# SERVICE AND APPLICATION NOTES

May 23, 2014  
 Re-issued May 27, 2014  
 H-14-04

## SLP98UHV & EL296UHV With Possible Incorrect Unit Size Codes

Figure 2

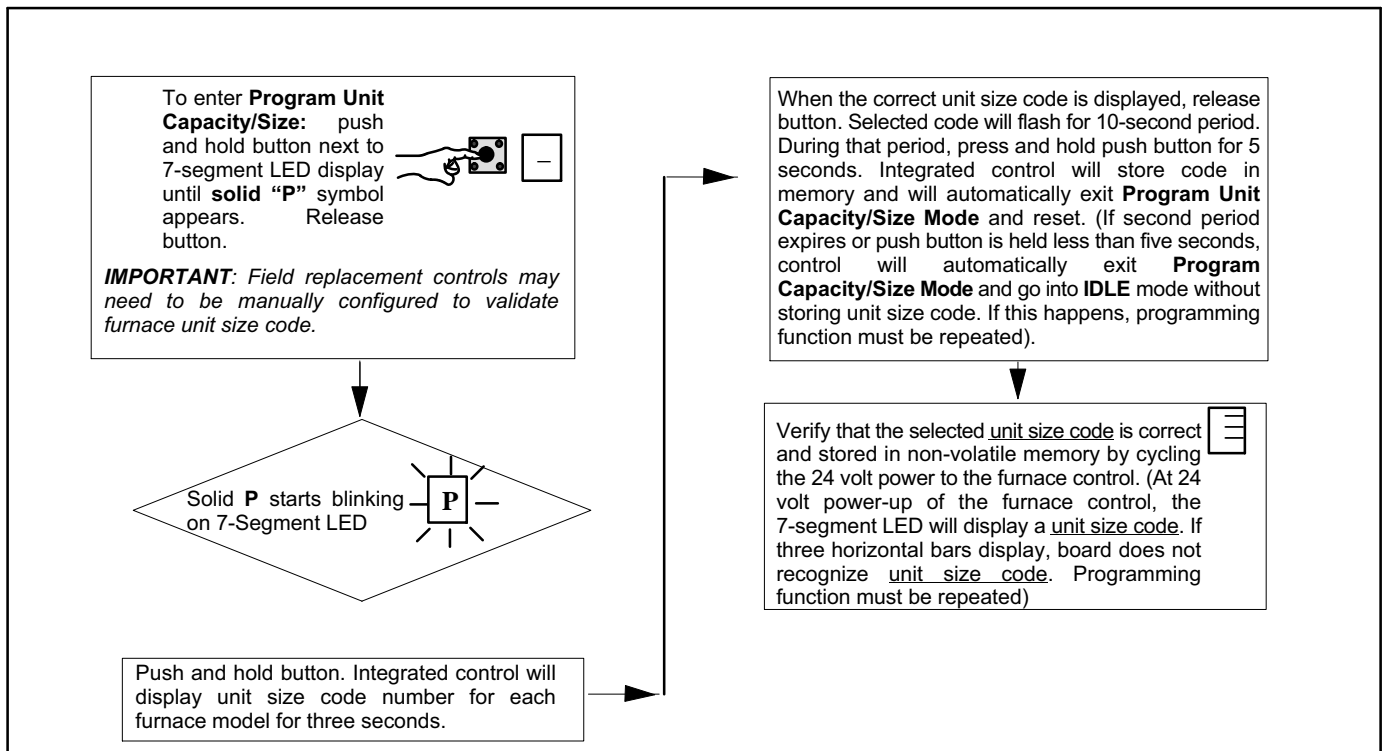
If the unit size code does not match, the ignition control will display a E202 error code upon power up. Re-program the integrated control using the procedure in figure 2.

If the serial number does not match, the furnace will operate normally, but the iComfort thermostat will display the incorrect serial number programmed into the control. If the model number is incorrect, the furnace will display an E202 error code upon start up. To correct these issues, order a new integrated control for the furnace using one of the following repair part kit catalog numbers:

Install the new integrated control **WITHOUT** connecting the i+ and i- wires. Use the procedure in figure 2 to program the correct Unit Size Code from figure 1 into the new integrated control. After verifying the correct code has been programmed, remove power and re-connect the i+ and i- wires. Power up the system and select "No" on the iComfort thermostat when asked to "Copy Settings?". Refer to the instructions in the repair part control kit for the detailed steps.
